S U P P L E M E N T A R Y A S S E S S M E N T R E P O R T

RE: **DA 360/25 – 70-76 ALEXANDER STREET, CROWS NEST – DEFERRAL OF DETERMINATION - NSLPP MEETING 05 AUGUST 2026**

ASSESSMENT OF AMENDED PLANS

Figure 1 – 16m Height Plane Diagram – View 1 – A0400 Rev J

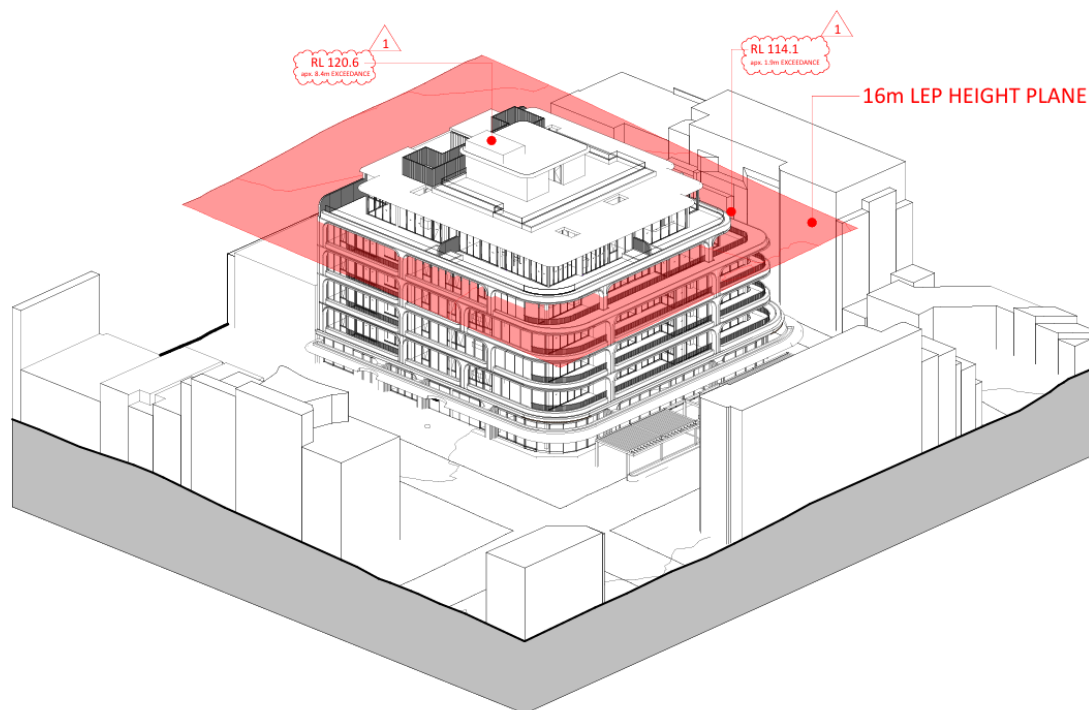
The amended Architectural Plans do not address reasons for refusal concerning Height of Building, and it is maintained the development application should be refused because the height of the building is excessive and fails to comply with the maximum building height development standard contained within the North Sydney Local Environmental Plan 2013 (NSLEP 2013).

- The building comprises of seven storeys (including roof) and a height of 23.6m to the roof (exceedance of 7.6m) and 24.4m to the lift overrun (exceedance of 8.4m). The proposed height is substantially greater than the 16m maximum height permitted for the site and exceeds the height of any adjoining sites that are limited to 10m, as well as the nearby R2 Low Density Residential Zoned Land.

Figure 3 – Section 01 – A0300 Rev M

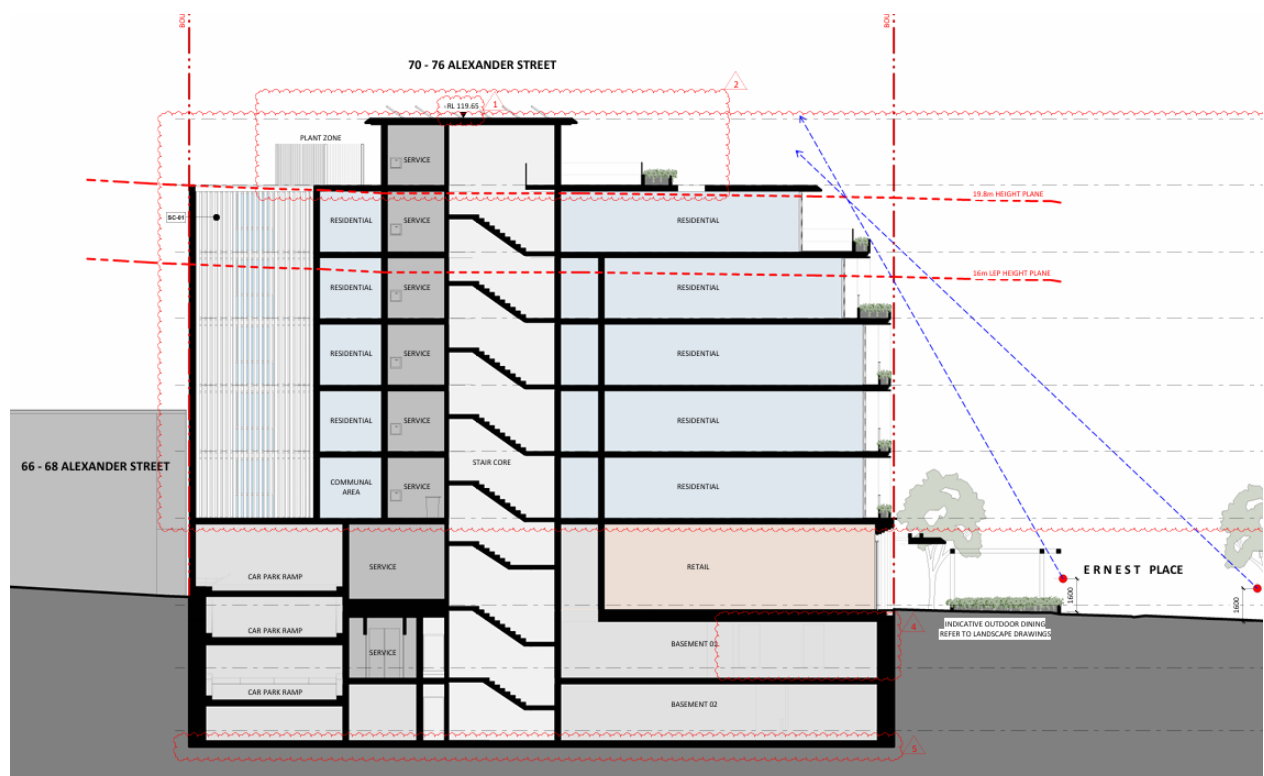
The development application should be refused because the built form specifically the podium heights and scale of built form for the rooftop are excessive and the development does not comply with the applicable Objectives and Provisions contained within Section 2.4 'Quality Built Form' in Section 2 – Development in Employment and Mixed Use Zones of the North Sydney DCP 2025.

- The site is subject to a four (4) storey podium requirement for Ernest Street and Alexander Street and a three (3) storey podium requirement for Willoughby Lane. The Podium Heights Map in Figure F-3.2-4, Section 3.2.3.4 'Podium Heights' of the Crows Nest Town Centre Character Statement stipulated area specific podium height controls.

- The podium height for the proposed building is five (5) storeys to Alexander Street not in accordance with the desired built form directions for the Crows Nest Town Centre Character Statement contrary to Provision P1, Section 3.2.3.4 of the Character Statement and Provision P1, Section 2.4.3 of Section 2 – Development in Employment and Mixed Use Zones.

- The above podium setback to Ernest Street measures approximately 2.3m not compliant with the 3m above podium setback in Figure F-3.2-5, Section 3.2.3.5 'Above Podium Setbacks' of the Crows Nest Town Centre Character Statement.

- The podium height to Alexander Street is excessively high for its corner location and is not in accordance with the desired built form directions for the Crows Nest Town Centre Character Statement contrary to Provision P1, Section 3.2.3.4 of the Character Statement and Provision P1, Section 2.4.3 of Section 2 – Development in Employment and Mixed Use Zones. The above podium setback to Ernest Street is insufficient not in accordance with the directions in Provision P1, Section 3.2.3.5 of the Character Statement and the above podium setback does not achieve an appropriate scale of building to the street and public domain contrary to Objective O2, Section 3.2.3.5.
